# UNITED STATES PATENT AND TRADEMARK OFFICE

APPLICATION NO.	FILING DATE	FIRST NAMED INVENTOR	ATTORNEY DOCKET NO.	CONFIRMATION NO.
10/595,133	03/02/2006	Per Anders Stenberg	P18463-US1	3249

<b>Office Action Summary</b>	<b>Application No.</b> 10/595,133	<b>Applicant(s)</b> STENBERG ET AL.	
	<b>Examiner</b> Harry Liu	<b>Art Unit</b> 3662

### **DETAILED ACTION**

**FIG. 4**

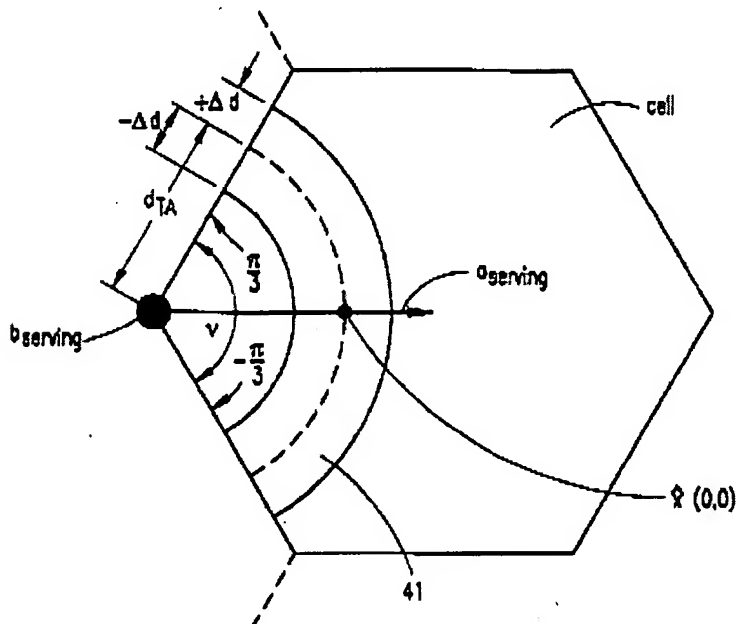
Regarding claims 1, 10, Larsson discloses the distance of a mobile transmitter to a site is determined by the propagation delay time/parameter (column 3, lines 34-42) and direction from the transmitter to the receiver (see Fig. 4 below).

**FIG. 2**

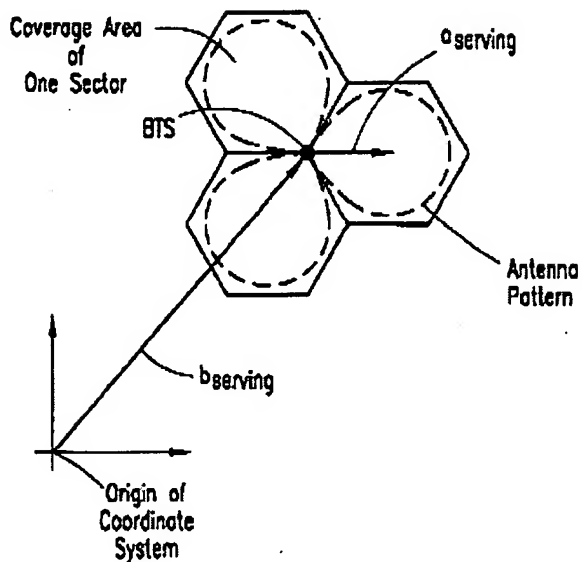
Regarding claims 2, 11, Larsson discloses the distance determination is based on at least one of the immediate neighbors of the cell where the transmitter is served (see FIG. 2 below).

**FIG. 15**

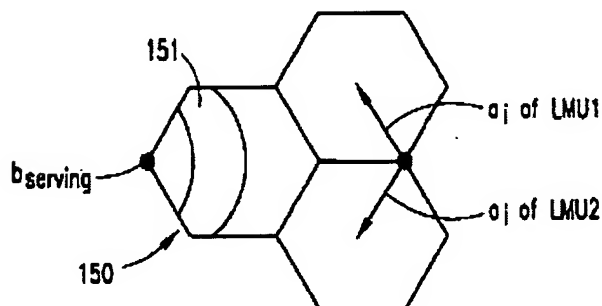
Regarding claims 3, 12, Larsson discloses the distance determination is based on a linear scale of or dB-scale difference (S/N ratio, see Fig. 15 below) (column 9, lines 16-28).

**Fig. 8**

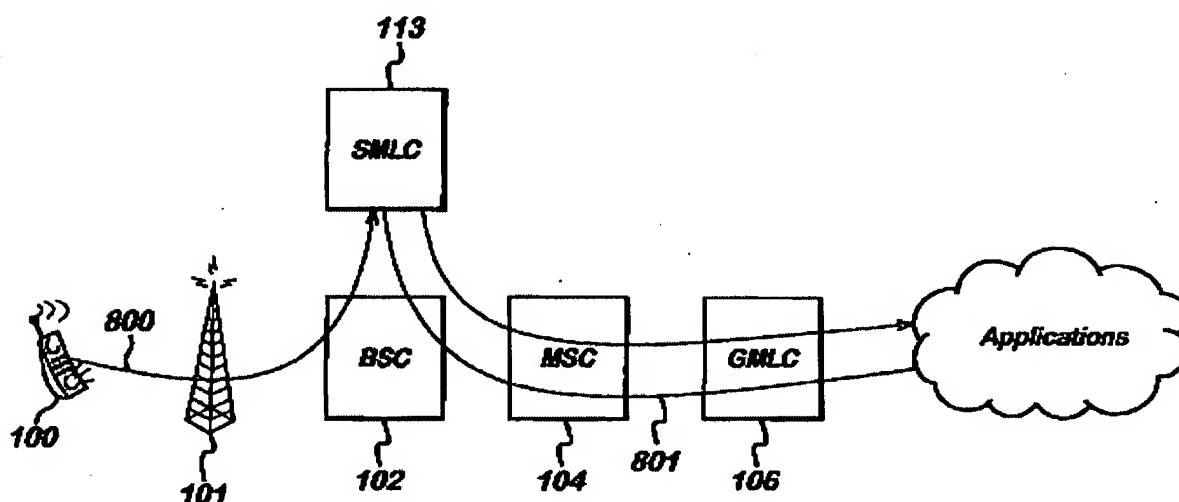
Regarding claims 6-9, 15-18, Larsson discloses the position determination based on average but fails to disclose the average is formed in a network control element (claims 6,15) or standardized interface (A-bis, lub) (claims 7, 16) or BSC (claims 8, 17) or RNC (claims 9, 18). However, Mannoja teaches the use of network control element

(SMC, BSC, see Fig. 8 below) and RNC (for column 3, lines 9-25)

controlling/calculating the position of mobile. It would have been obvious to modify Larsson with Mannoja by incorporating SMC, (A-bis, lub), BSC and RNC into the location service in order to satisfy GSM or UMTS system requirements.
